HVAC Submittal 230500-04

Job Name/Number: Bethany Elementary School – Job #2302002

PROJECT: BETHANY ELEMENTARY SCHOOL ADDITIONS
CLOVER, SC

EQUIPMENT: EXHAUST FANS BY LOREN COOK

MARK: EF-1

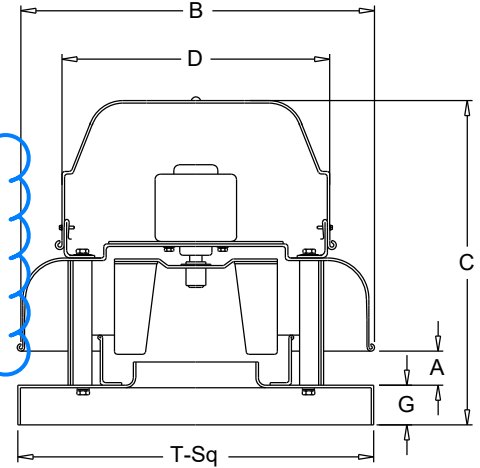
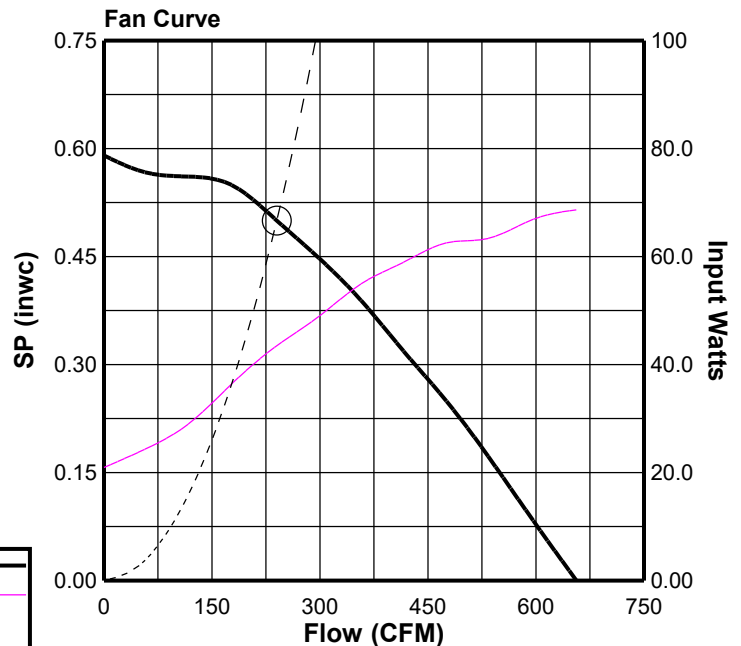
Per remark 1 on dwg M001, a belt tensioner is required for EF-1

Per the fan schedule on dwg M001, motor h.p. is specified to 1/10

MARK: EF-2

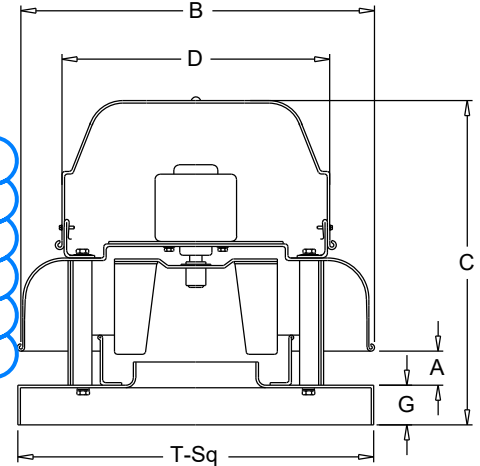
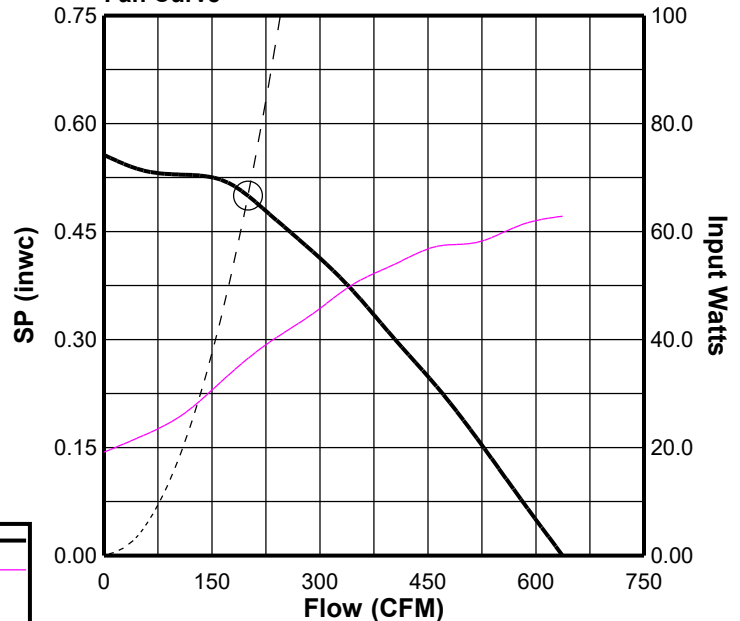
Per remark 1 on dwg M001, a belt tensioner is required for EF-1

Per the fan schedule on dwg M001, motor h.p. is specified to 1/10

Per dwg M001, remark 3, cooling thermostat to be provided/furnished
